Docket Number:	06-AFC-07C		
<b>Project Title:</b>	Humboldt Bay Generating Station - Compliance		
TN #:	213637		
Document Title:	Humboldt Bay Generating Station Notice of Determination for petition to install a fiber optic line		
Description:	Humboldt Bay Generating Station Notice of Determination for petition to install a fiber optic line		
Filer:	Bruce Boyer		
Organization:	California Energy Commission		
Submitter Role:	Commission Staff		
Submission Date:	9/14/2016 9:39:53 AM		
<b>Docketed Date:</b>	9/14/2016

## NOTICE OF DETERMINATION

# PETITION TO AMEND HUMBOLDT BAY GENERATING STATION (06-AFC-7C)

FIGURE 1
Humboldt Bay Generating Station - Census 2010 Minority Population by Census Block

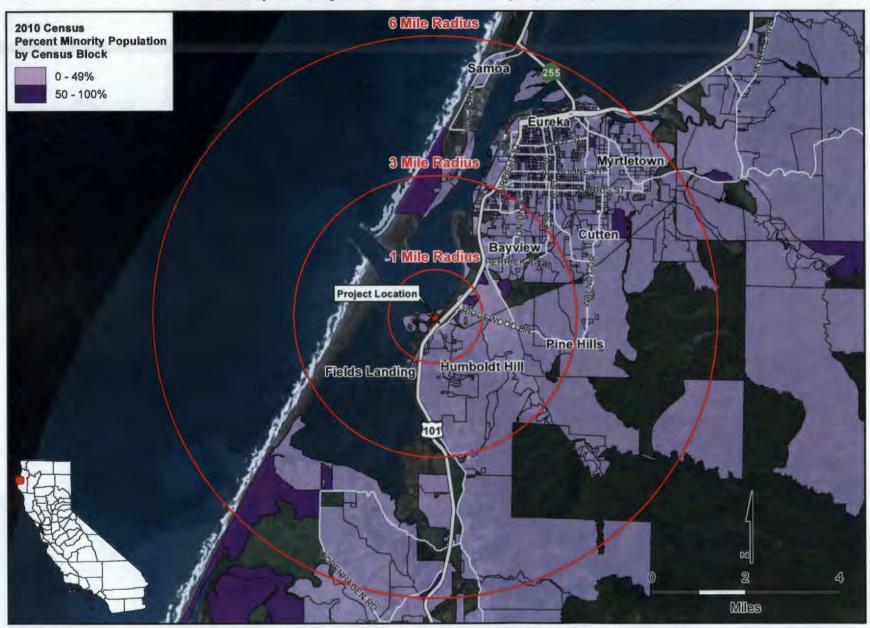
The **Environmental Justice Population Figure** shows 2010 census blocks in the six-mile radius of the HBGS with a minority population greater than or equal to 50 percent. The population in these census blocks represents an EJ population based on race and ethnicity as defined in the Council on Environmental Quality's *Environmental Justice: Guidance Under the National Environmental Policy Act*.

Impacts would be less than significant with the project's continued compliance with existing conditions of certification. Therefore, impacts would be less than significant for any population in the project's six-mile radius, including the EJ population represented in Figure 1 (HBGS Census 2010 Minority Population by Census Block) and Table 2 (Poverty Data within the Project Area).
